*City of Albuquerque*  
*Environmental Planning Commission*

*Staff Report*

| <b>PROJECT#:</b>             | PR-2019-002284                                                                                                                                                                                                                                                                                                                                                                                                                                                                                                                                                                                                                                                                                                                                                                                                                                                                                         |
| <b>APPLICATION:</b>          | Major Amendment to a Site Plan – EPC

**B1** SIGNAGE DETAILS - ENTRANCE - SOUTH ELEVATION

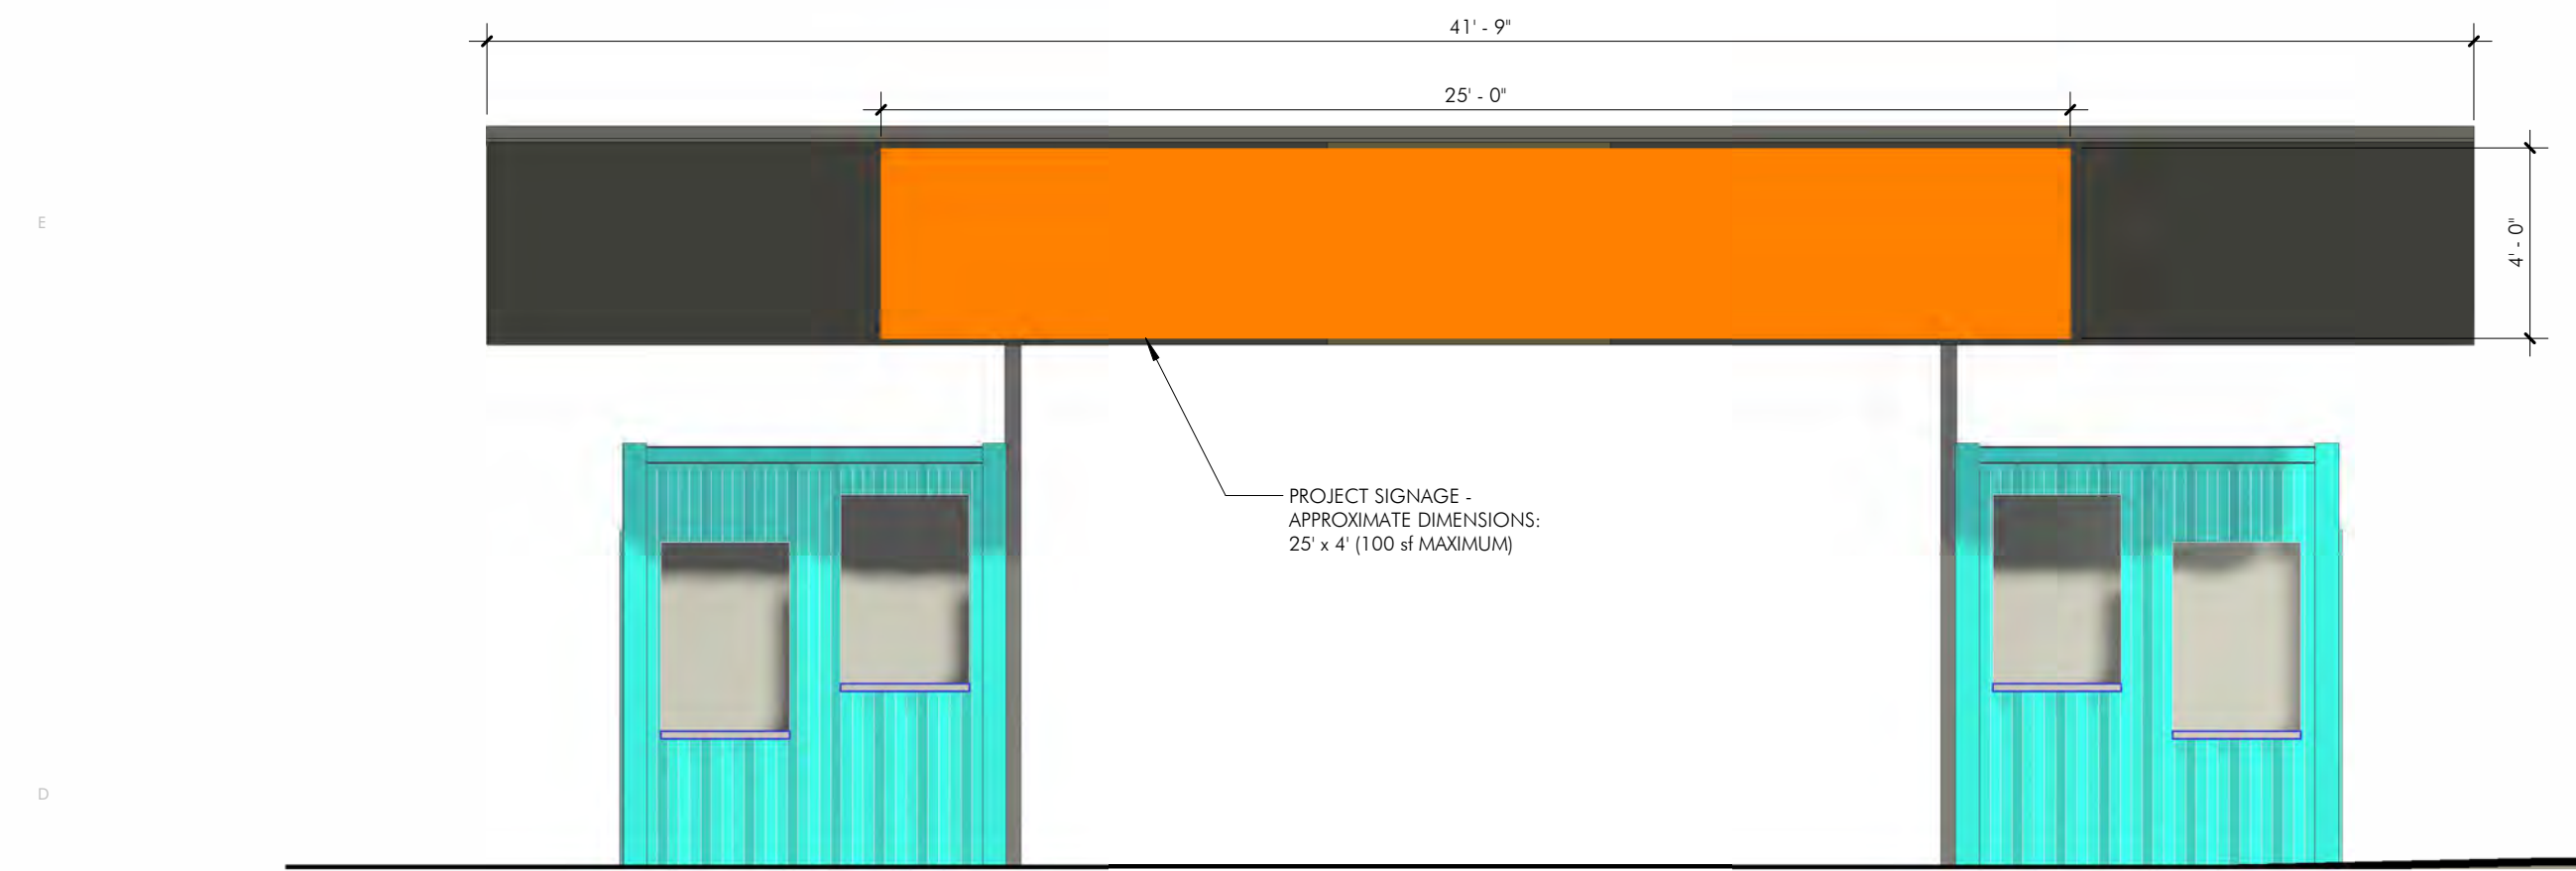
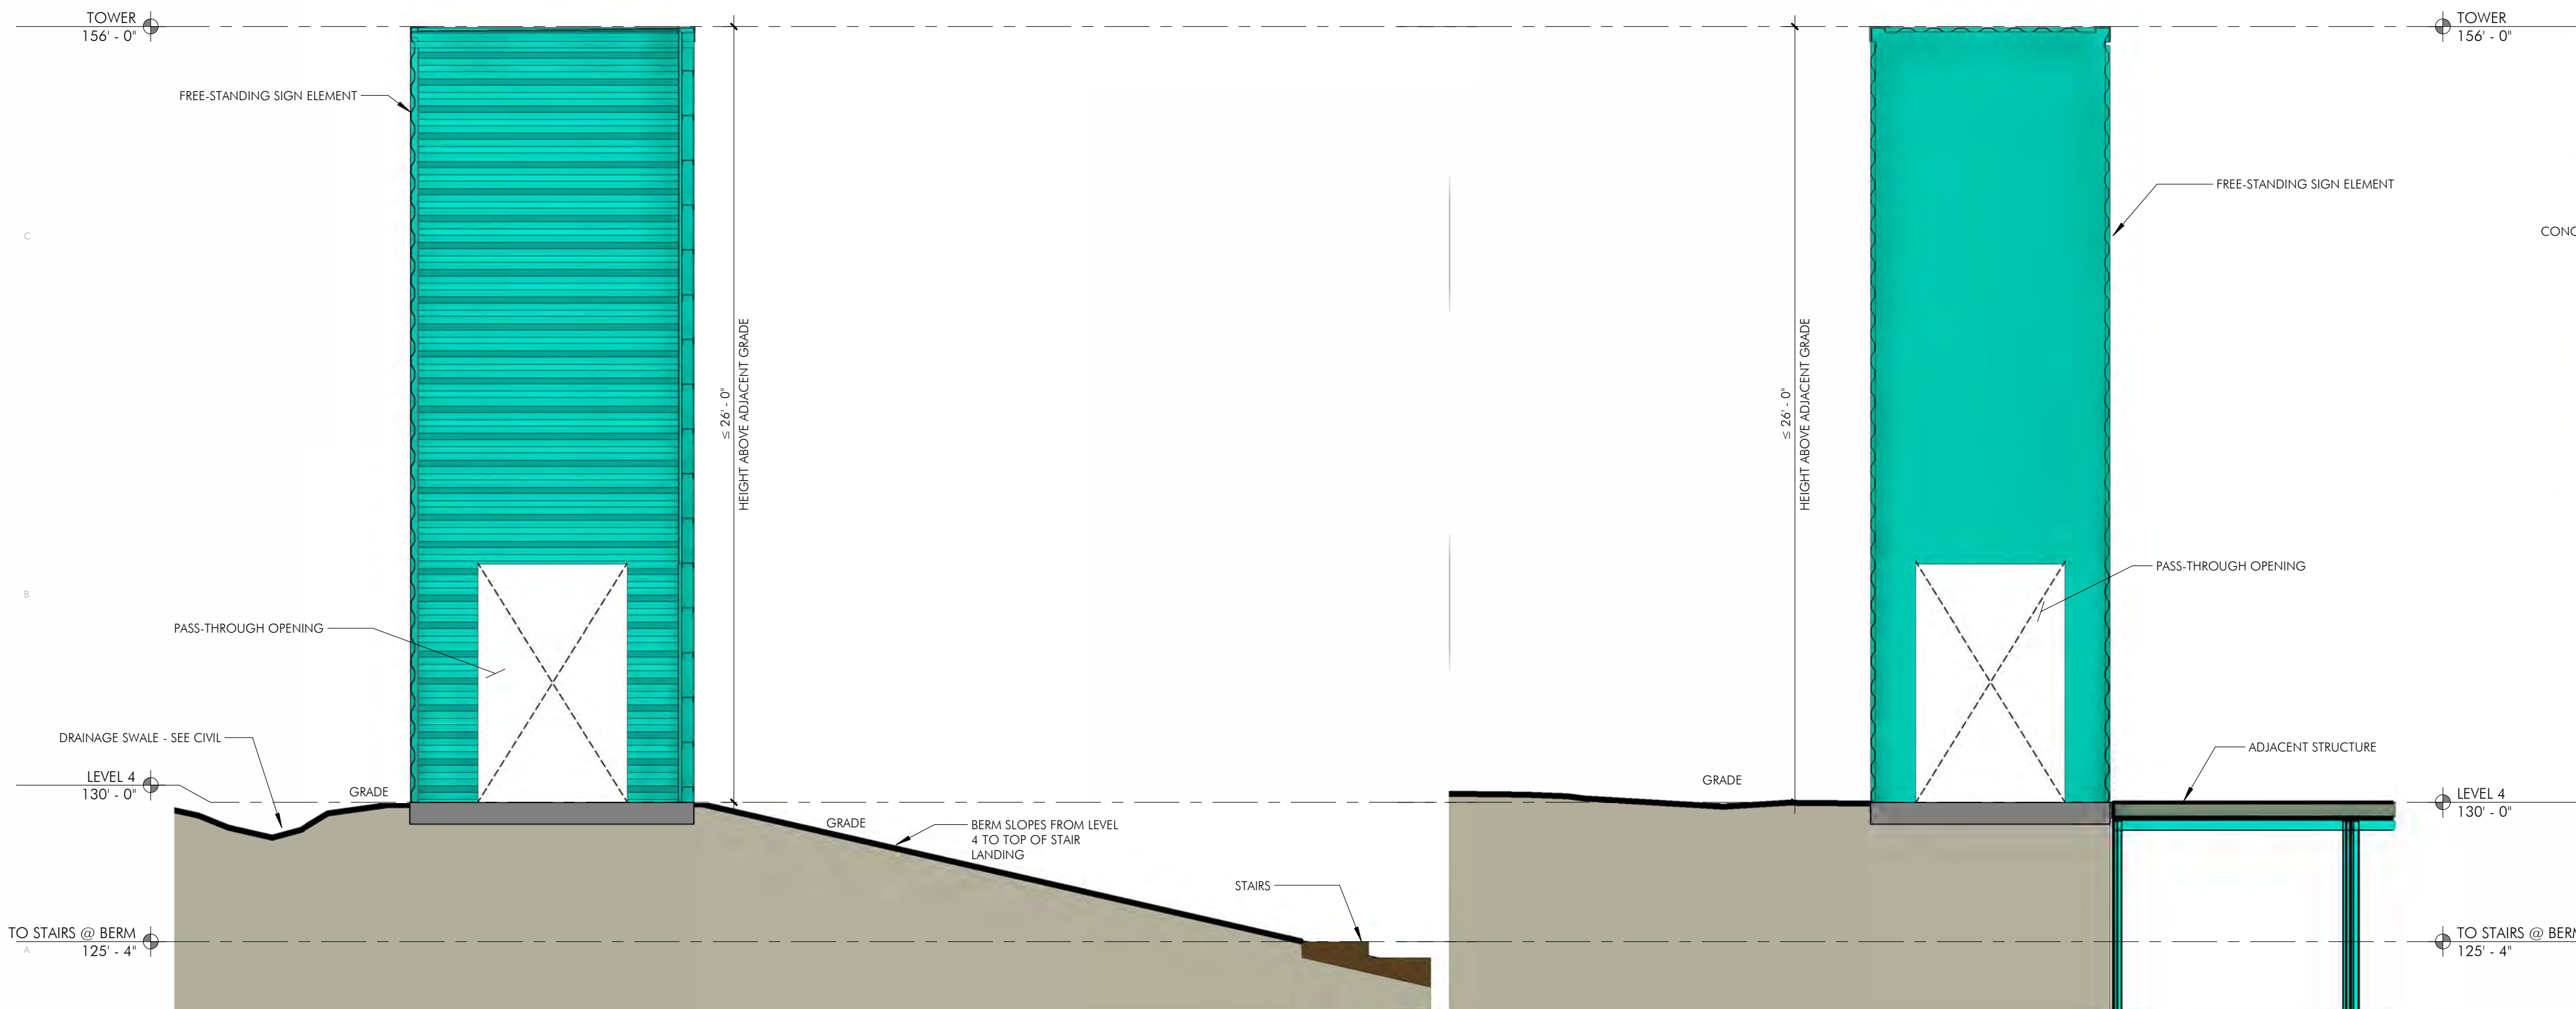
5. Signage: The main entrance canopy sign shown on Signage Detail Sheet A-501 shall be reduced so that its width does not exceed 50 percent of the canopy frontage, as required by IDO Table 5-12-3. The Final Sign Plan shall demonstrate compliance with all applicable dimensional and design standards of IDO §14-16-5-12 prior issuance of any required sign permits.
